BID ADDENDUM #3

Nanuet Union Free School District 103 Church Street Nanuet, NY 10954

Nanuet Bond Projects Phase 4

Date: March 29, 2024

HS-M113

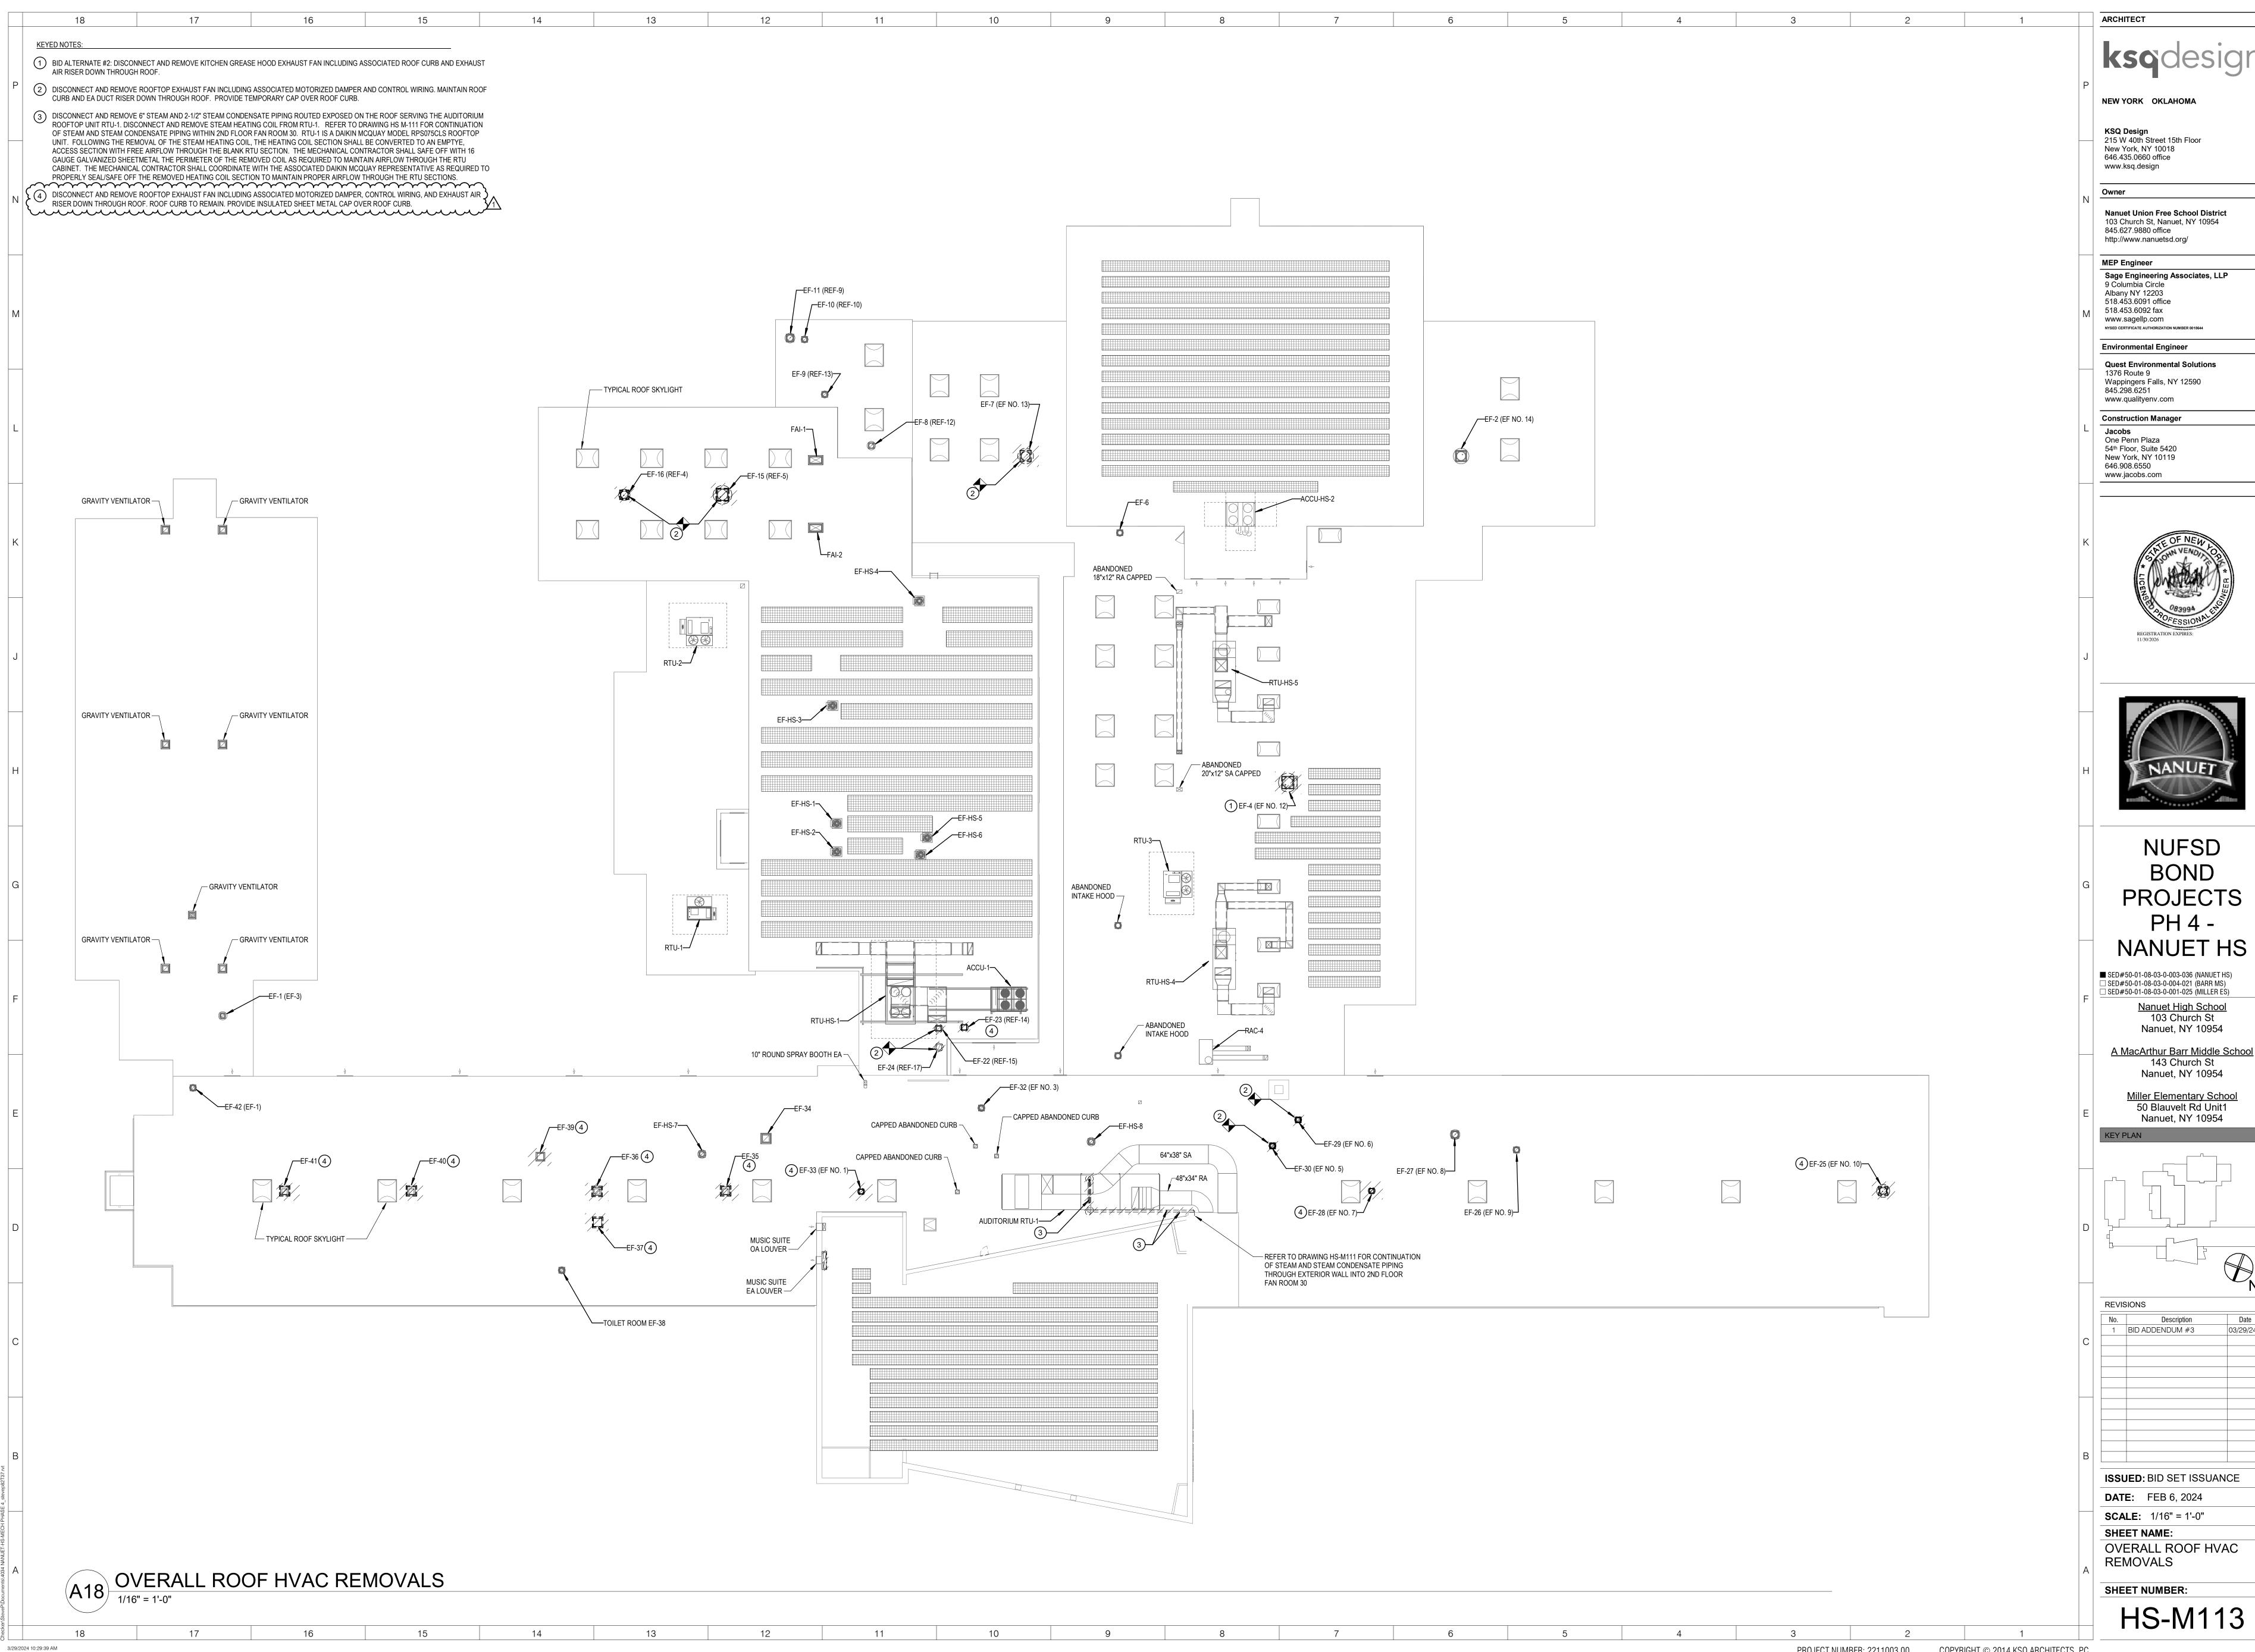
| | None |
|-------|--|
| MECH | ANICAL At High School roof where exhaust fans are to be removed curbs are to remain in place and to be capped with insulated sheet metal. See attached Mechanical sheets. |
